Responses to comments by Reviewer #1

The article used an analytical tidal model to understand the change of freshwater discharge on the tidal dynamics in the Yangtze River, with a specific focus on the impact of Three Gorge Dam. While freshwater discharge's effect on tidal dynamics is well recognized by observations and numerical models, it is rare to use an analytical tool to understand the underlying mechanism (e.g., bottom friction, tidal damping) for the changes in tidal dynamics. I believe the article is a good example study for the influence of dam construction. There are some issues, however, needed to be well resolved before acceptance for publication.

Figure R1. Longitudinal variability of simulated tidal damping number δ (a, c, e, g) and celerity number λ (b, d, g, i) along the Yangtze estuary in different seasons (spring: a, b; summer: c, d; autumn: e, g; winter: g, i) for both the pre-TGD and the post-TGD periods.

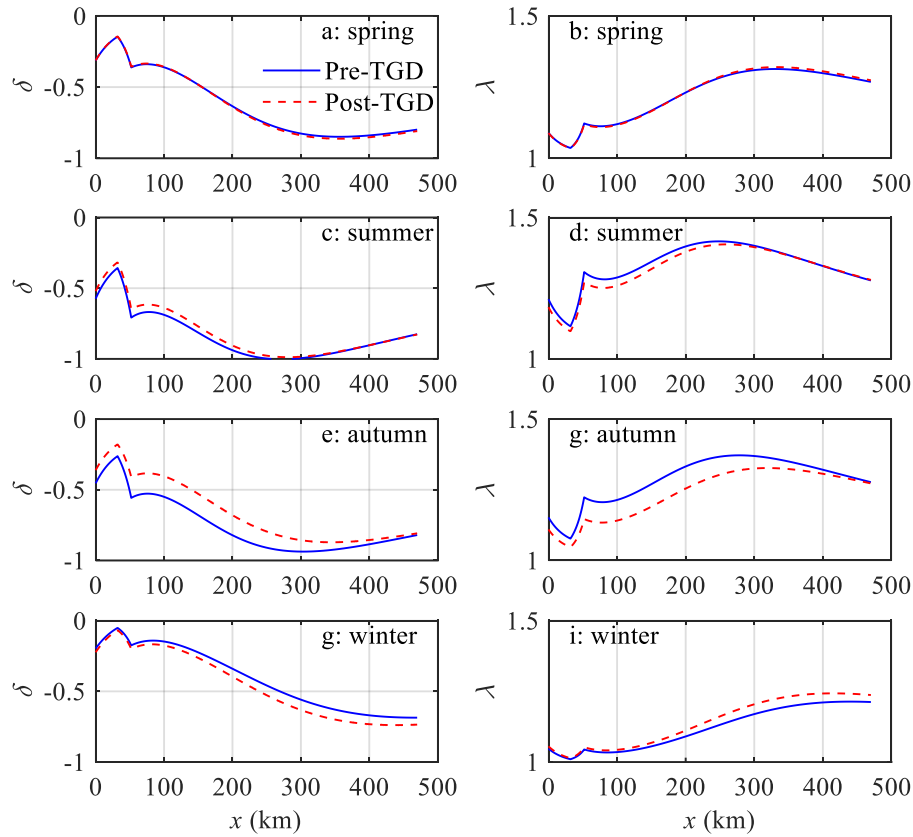
4. Regarding the TGD's influence on damping rate as shown in Fig. 3, could you explain why there so many jumping values (e.g., in Fig. 3a,c,d,e)? For an analytical solution with so many simplification assumptions, the response shall be in a much smoother way. Is such a jumping pattern observed in reality? I think it is important to clarify such abnormal features in your figures. Such types of not explained pattern also exist for figure 6-9, where there is a clear jumping pattern. Is it because you are using two manning coefficients for different regions?

Figure 6: why there is sharply jumping in the curve, due to different manning coefficient?

For the jumping behavior in Figures 6-9, this has to do with the adoption of two very different Manning-Strickler friction coefficient in the seaward and landward regions. In the revised paper, to avoid such a sharp jump in the curves and to improve the model performance, we will adopt a friction coefficient of $K=80-55 \text{ m}^{1/3}\text{s}^{-1}$ (indicating

a linear reduction of the friction coefficient) over the transitional reach ($x=32-52$ km) in the analytical model. Figures R1-R4 below show the updated Figures 6-9 using a linear reduction of the friction coefficient in the transitional reach, where we observe a smooth transition of the analytically computed variables.

Our reply: Indeed, the discontinuous jump has to do with the adoption of two very different Manning-Strickler friction coefficient. To avoid such a sharp jump in the curve, in the revised paper, we shall adopt a friction coefficient of $K=80-55 \text{ m}^{1/3}\text{s}^{-1}$

(indicating a linear reduction of the friction coefficient) over the transitional reach ($x=32-52$ km).
